PCN# 20170130000

Allow Processor Power Down

One change to the MitySOM-335x modules is identified in the following section.

Change 1 – Allow Processor Power Down

Figure 1: Example schematic for connecting a power button

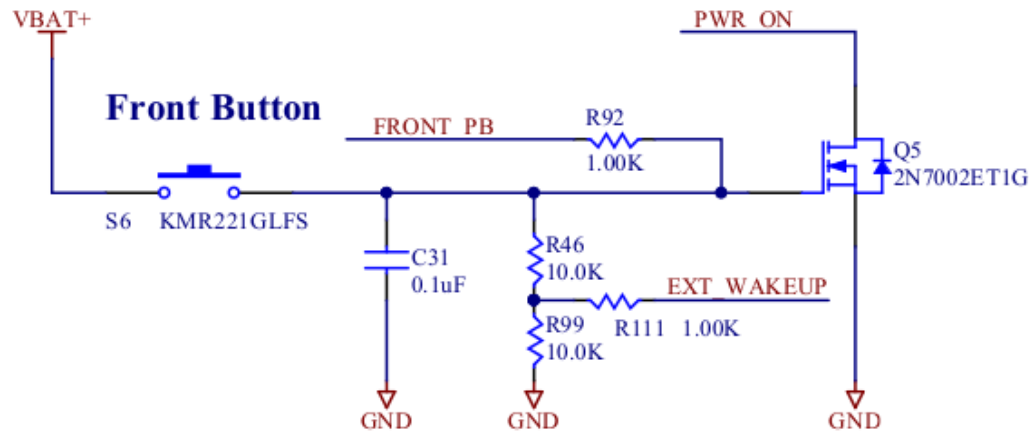
Portable applications generally desire the ability to power-down and save battery power. The original MitySOM design targeted always-on use cases, and did not have a functional power-down feature. The power on reset was configured such that the unit automatically powered back up when the AM335x RTC is configured to power down the Power Management Integrated Circuit (PMIC).

To correct this, the power on reset is pulled high (inactive) for as long as power is applied, so that the AM335x RTC remains active, even during power-down. The unit will stay at a low power state after power-down until a power button is pressed, which is connected to PWR_ON (PMIC PWRON, Pin 33, Module Pin 32) and EXT_WAKEUP (AM335x EXT_WAKEUP, Module Pin 180). Note that there is still some minimal circuitry active when powered down.

To use this newly supported feature, the PWR_ON (PMIC PWRON, Pin 33, Module Pin 32) and EXT_WAKEUP (AM335x EXT_WAKEUP, Module Pin 180) will need to be connected to a power button and the kernel will need to be updated to configure the AM335x RTC to power down (See Figure 1 for an example circuit). Note that EXT_WAKEUP is on a 1.8V power domain; the voltage divider is shown in Figure 1. Please contact Critical Link if designing a system using this feature.
